Office Action Summary	Application No. 10/572,679	Applicant(s) ONO ET AL.	
	Examiner CLIFFORD J. LOUDEN	Art Unit 3679

DETAILED ACTION

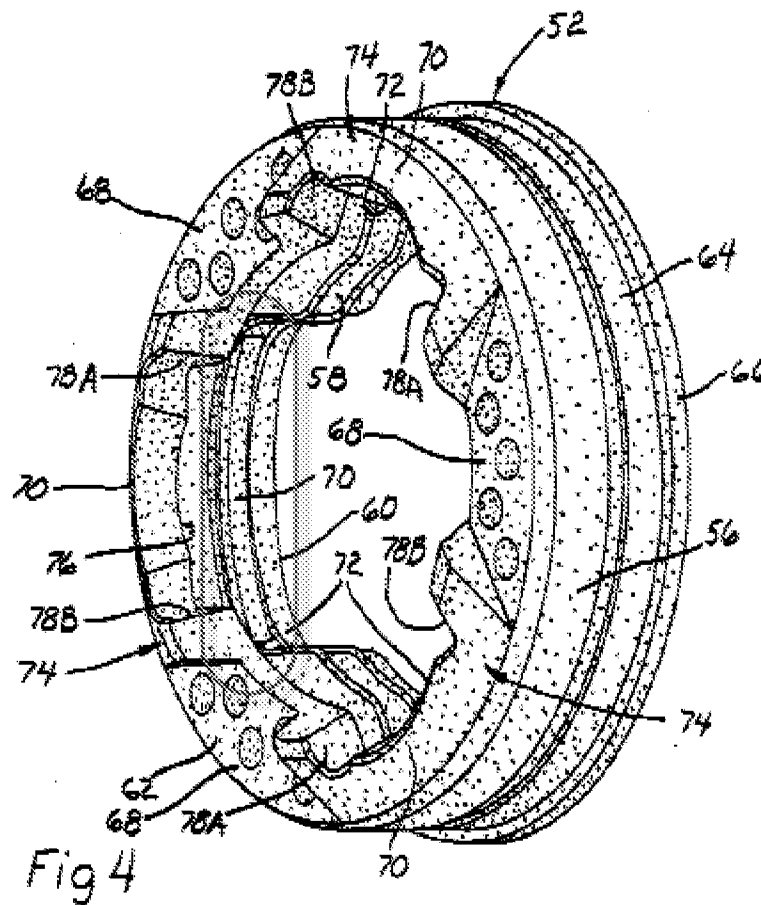
7. Claim 1 is rejected under 35 U.S.C. 103(a) as being unpatentable over Schulz et al., US 5,529,538. Schulz et al. show a universal joint boot comprising: a cylindrical bellows part (42) that has valley and peaks formed continuously in a repetitive manner (shown in Fig. 1) and can extend and contract (shown in Fig. 2); a ring-shaped mounting part (52) that is formed at one end of the bellows part and into which a case (12) for receiving one member of two members moving relatively to each other is inserted (shown in Fig. 1); and a seal lip (70) that is formed toward a peripheral direction of an inner peripheral surface of the mounting part to which the case is mounted (shown in Fig. 4), wherein the inner peripheral surface has protrusions (68) protruding toward an axial center of the ring-shaped mounting part, and wherein a height of the seal lip becomes lower from a bottom of the protrusion to a peak (shown encircled in the diagram below).

Schulz et al. do not expressly disclose wherein a width of the seal lip becomes wider from the bottom of the protrusion to the peak. However, at the time of the invention, it would have been obvious to one of ordinary skill in the art to modify the seal lip to provide an increase of surface area for the purpose of improving the frictional seal between the bushing and the tulip housing.
